Bike Auckland
Barbara Cuthbert (Chair)
barbcuth@gmail.com
Mobile: 027412582
2A St Aubyn Street
Devonport
Auckland 0624

Bike Auckland submission on East West Link proposal

Image 06: Showing the concept of the reconstructed Panama Road bridge with shared paths only (noting that the key calls out the green sections as footpaths - they are not cycle lanes)

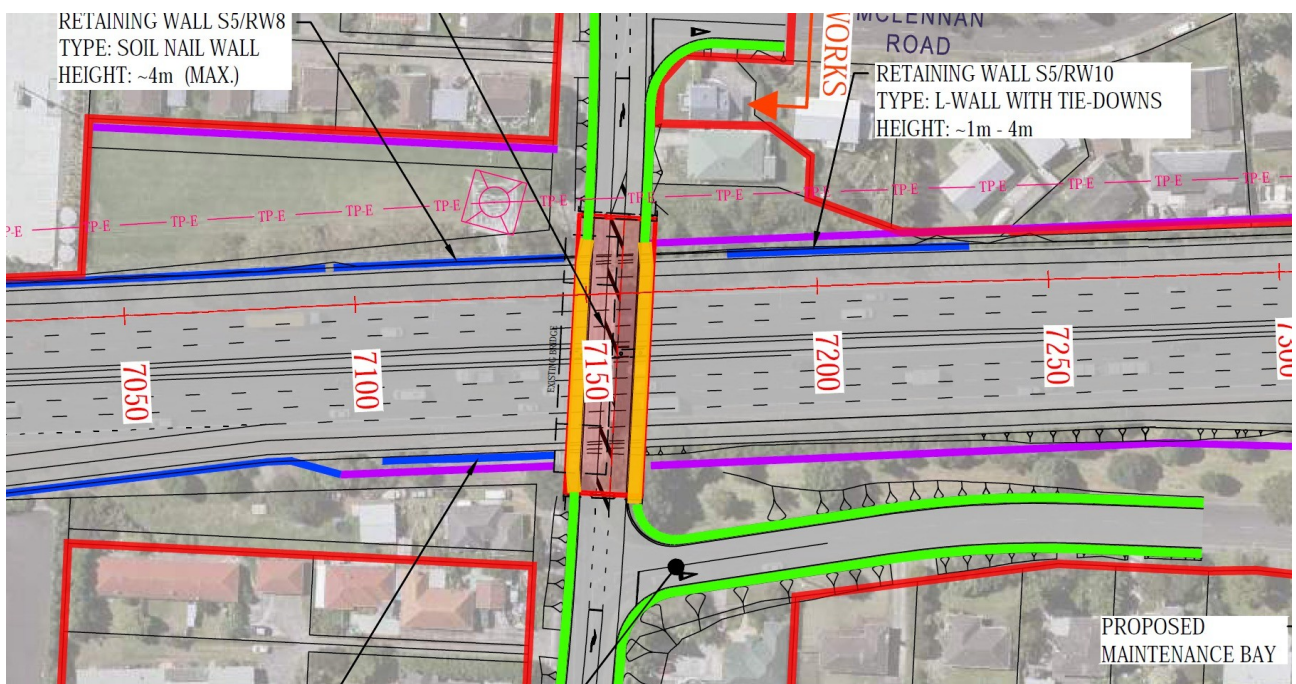
We are concerned that the proposed design for the new Panama Road bridge provides only shared paths, despite the unique opportunity that a full bridge rebuild affords to provide dedicated cycle facilities separate from both vehicles and pedestrians.

Additionally, the proposal currently shows these shared paths virtually only on the bridge deck itself. It thus does not - not even at concept level - resolve the issue of utility (how riders would effectively and safely enter and exit the proposed paths in a busy roading environment, including a nearby intersection). The concept is visible in Image 06.

Panama Road is one of the (very few) local connections across the barrier of State Highway 1 in the area. A high-quality walking and cycling design, which does not cement into place a lesser outcome for decades or even generations, will thus be extremely important.

Key request 5 (Sector 5): Require the design for the new Panama Road bridge over SH1 to provide best practice cycle facilities (i.e. separate from both pedestrians and motor vehicles), to avoid permanently limiting key local cycle connectivity - despite a brand new bridge being built.

Image 10: Showing the lacking southbound facilities for people on bikes, with no practical space left in the corridor to provide them on Great South Road later

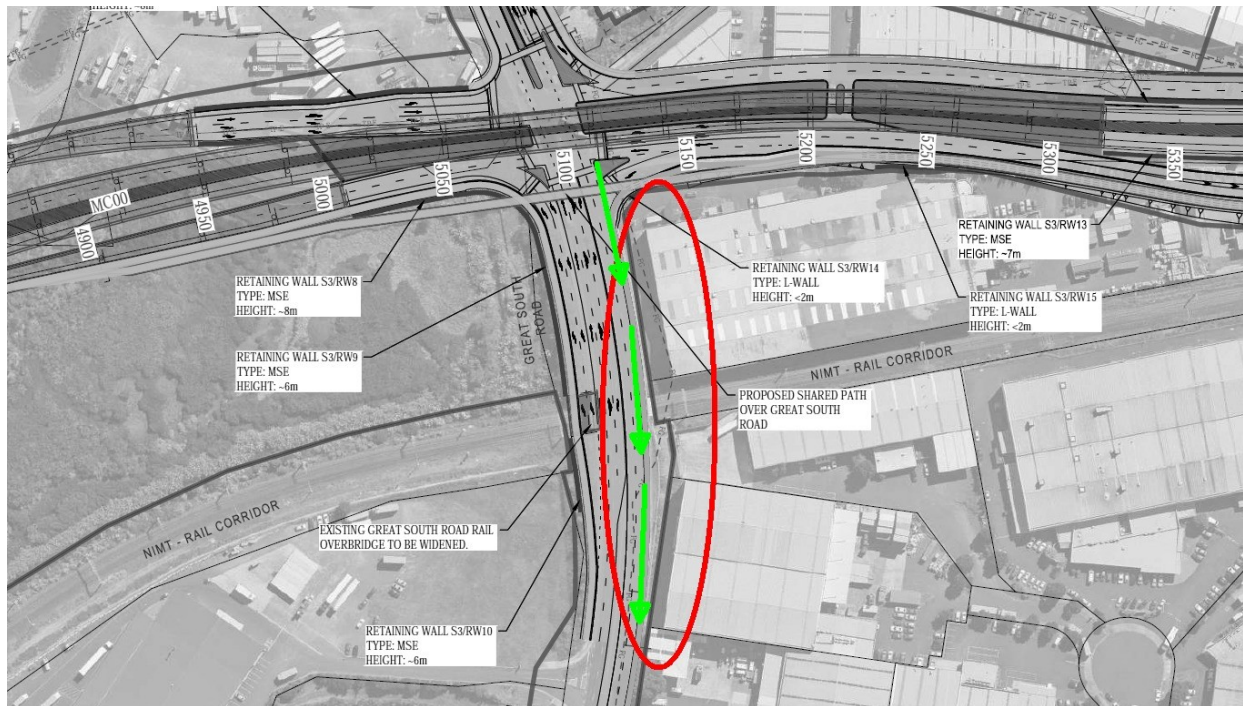
- The proposed design of the Great South Road / East West Link at grade intersection is missing cycle facilities in the south-eastern quadrant. Since the proposal's current design maximises and fills the available space in this corridor, and since large buildings directly abut it to the east, it will likely be very difficult & costly to add these in the future.

The future cycle facilities along Great South Road are very likely to be one-way facilities on each side (two-way facilities being inappropriate for urban roads with numerous industrial driveways). Therefore, the gap in cycle facilities on the eastern side will mean that southbound cyclists on any future facility will be particularly disadvantaged, and will likely be asked to switch over to the western side, adding multiple unnecessary signal crossings.

Key request 08e (Section 3): The current design of the Great South Road / East West Link intersection creates a significant issue for the future Auckland Cycle Network facilities - by not providing space for southbound cycle facilities in the south-eastern quadrant. This needs to be avoided by providing these now, or confirming practical future-proofing space.
